ARC REVIEW CODE: R2003131

TO: Mayor Rochelle Robinson
ATTN TO: Patrice Williams, Community Development Director
FROM: Douglas R. Hooker, Executive Director
RE: Development of Regional Impact Review

Name of Proposal: IDI Douglasville (DRI #3072)*

Description: A Development of Regional Impact (DRI) review of a proposal to build two distribution warehouses totaling 1,063,000 SF in the City of Douglasville. The site is located on the south side of Riverside Parkway near Roberts Road. Access will be provided to one building with an improvement of the existing Roberts Road and to the other building with two new driveways on Riverside Parkway. The local trigger is a rezoning. Expected buildout is 2023.

SITE PLAN OVERALL	
IDI	
RIVERSIDE WEST	
ADDRESS

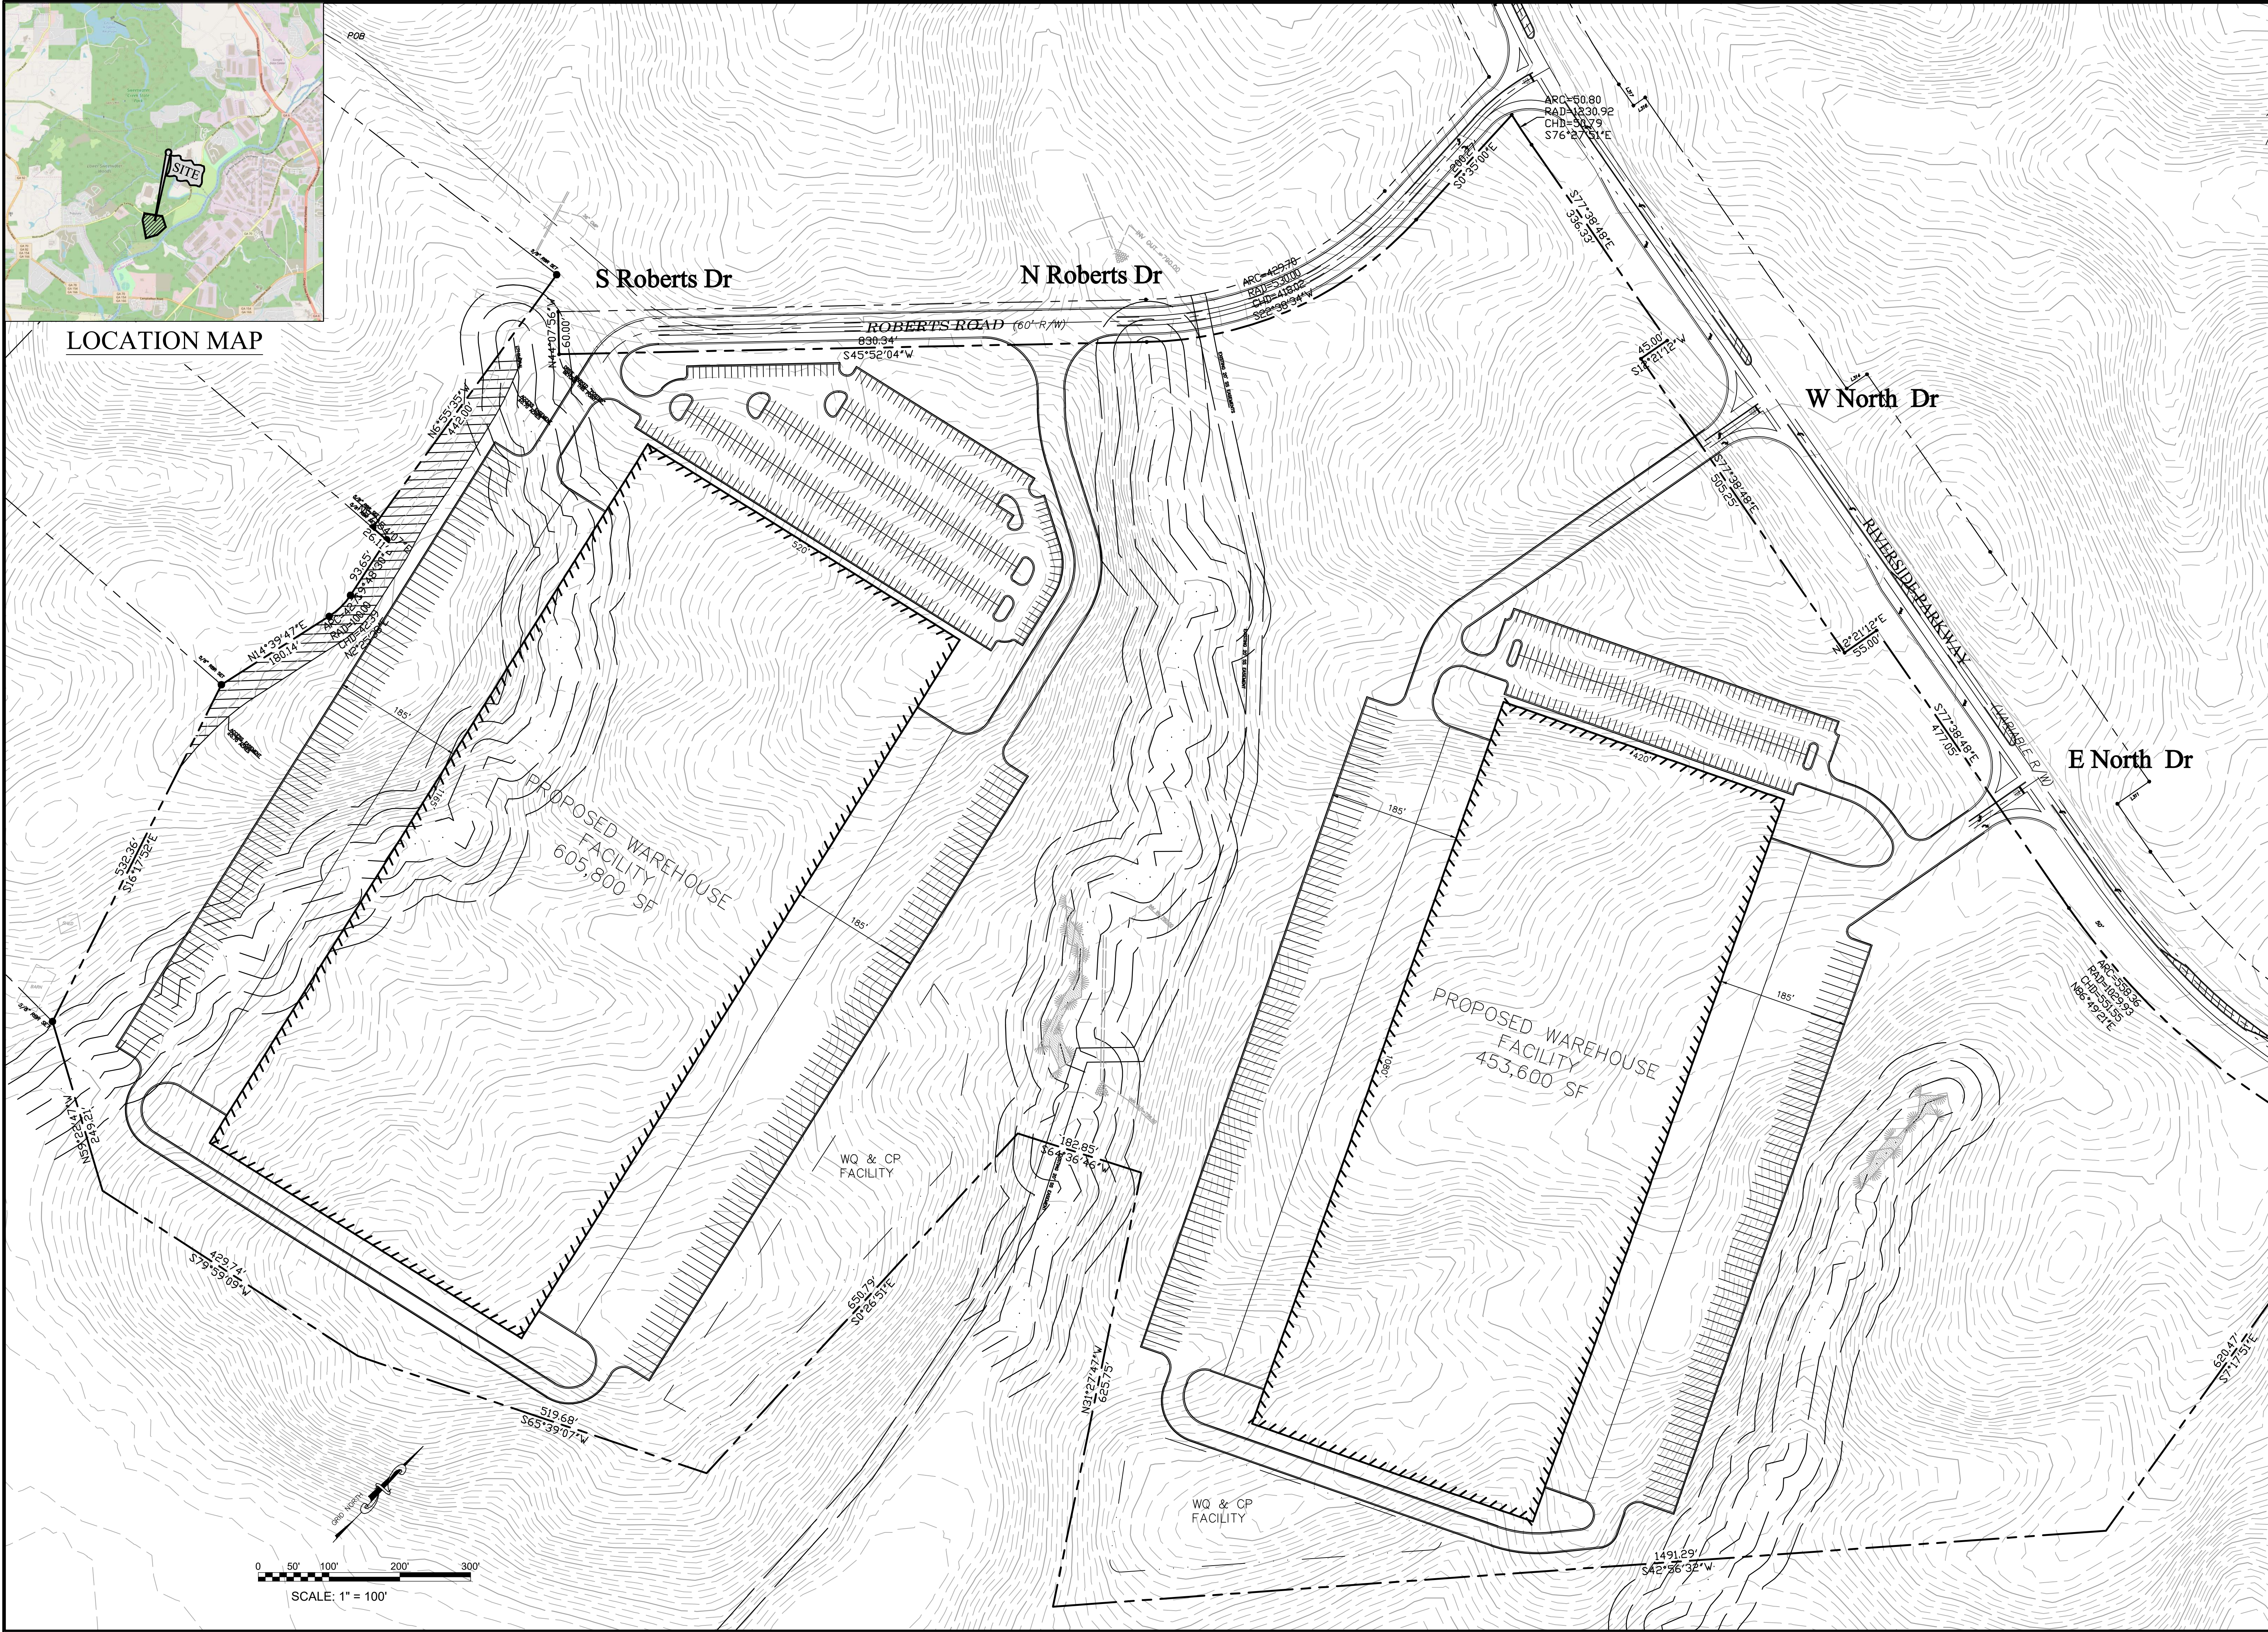
The site plan depicts two driveways proposed on Roberts Road and two on Riverside Parkway, neither designated as regional thoroughfare

Access to adjacent parcels can be accessed by Roberts Road, a local Or Riverside Parkway which is a local road. The site plan also shows a stub out for future inter-parcel connectivity.

No facilities are proposed for pedestrian use internal to the site. The truck traffic combined with vehicle traffic makes hinders safe bike ped use on site.

The site plan does not depict external pedestrian facilities along the property boundary, however it does not preclude it.

Multiple drive access points are proposed for the development however the proposed site plan does not segregate truck traffic by vehicle traffic through separate driveways, allowing them to mingle.

It is recommended that the western most entrance on Riverside be designated for vehicular traffic only and adequate turn lane length is provide for multiple trucks attempting to turn left.
